Town and Country Planning Act 1990 (As Amended)
Section 73 Application to Vary Conditions 2, 4 and 5 of Householder Planning Permission 2023/2056/P that relates to Proposed Erection of Outbuilding and Replacement Boundary Fencing in Rear Garden at No. 15 Crediton Hill, London, NW6 1HS

Revised Scheme vs Approved Scheme

Revised Scheme

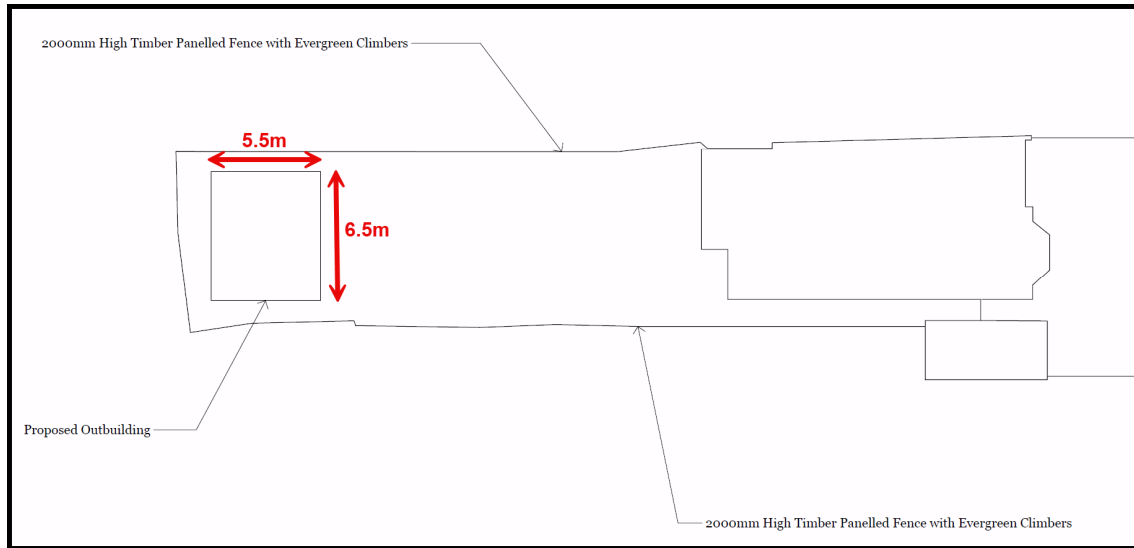
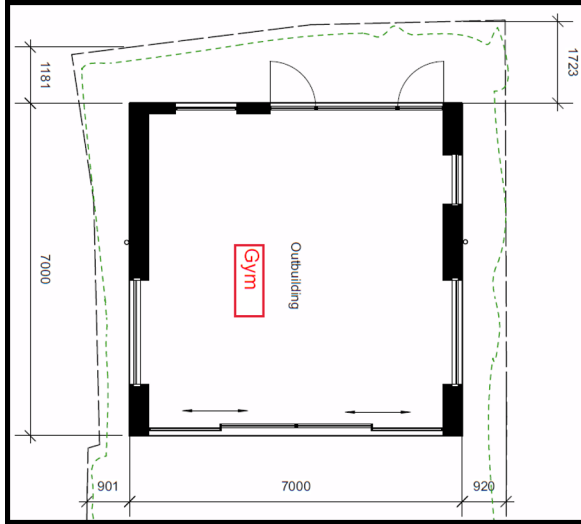
In terms of the proposed outbuilding, the Approved Scheme measures 7m wide by 7m in depth and by 2.95m high and that this is shown below.

In the Revised Scheme (as shown below), the proposed outbuilding is slightly smaller in footprint and measures 6.5m by 5.5m in depth and by 2.95m high. However, there is no change in terms of height between the Approved Scheme and the Revised Scheme; nor any changes in relation to the proposed timber boundary fencing – i.e. this remains the same at 2m high.

In the Revised Scheme, we remain committed to having a sedum planted roof in-line with the Approved Scheme. The only change on the flat roof relates to the proposed insertion of a small rooflight measuring 1m by 1.5m and be flush with the roof level and close to the north-western corner of the structure and to serve the incidental 'home office' use.

Revised Scheme

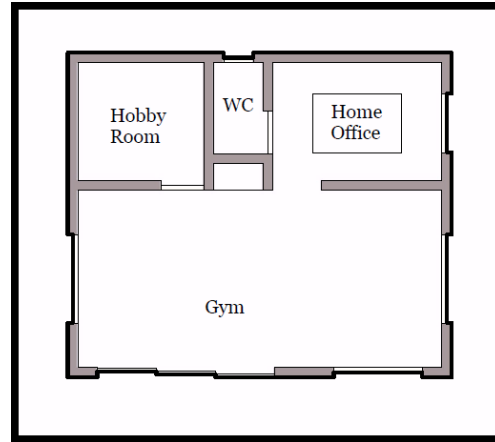
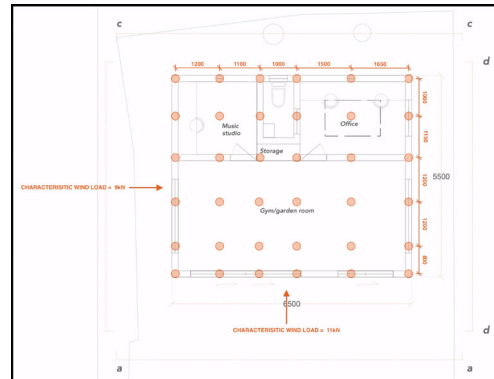
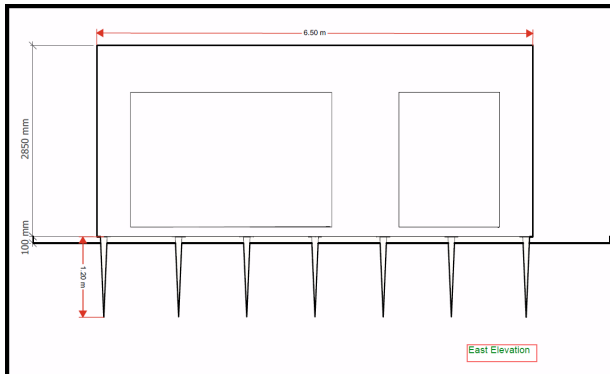
The Approved Scheme shows the outbuilding as wholly used as a home gym; but in the Revised Scheme, the applicant wishes to bring other incidental uses and functionality to the outbuilding – i.e. as a home gym; home office (served by an ensuite W.C); and hobby room. We consider such change remain as incidental uses to the main single family dwelling. These changes have led to the need to amend the fenestration of the outbuilding. Overall, there is less glazing in the Revised Scheme.

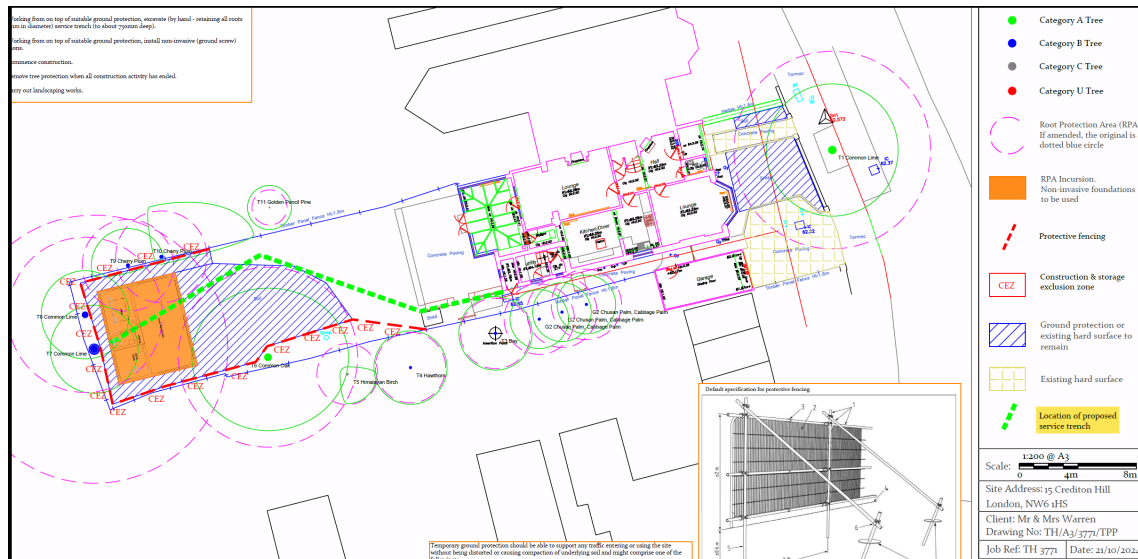
We have also submitted an updated Tree Report and associated plans showing details of the proposed screw pile foundations at total height of 1.2m but to entrench 1.1m deep into the ground.

Details of the service trench is shown in the submitted Tree Report (see Appendix 9 – Tree Protection Plan) and an extract of this is shown below.
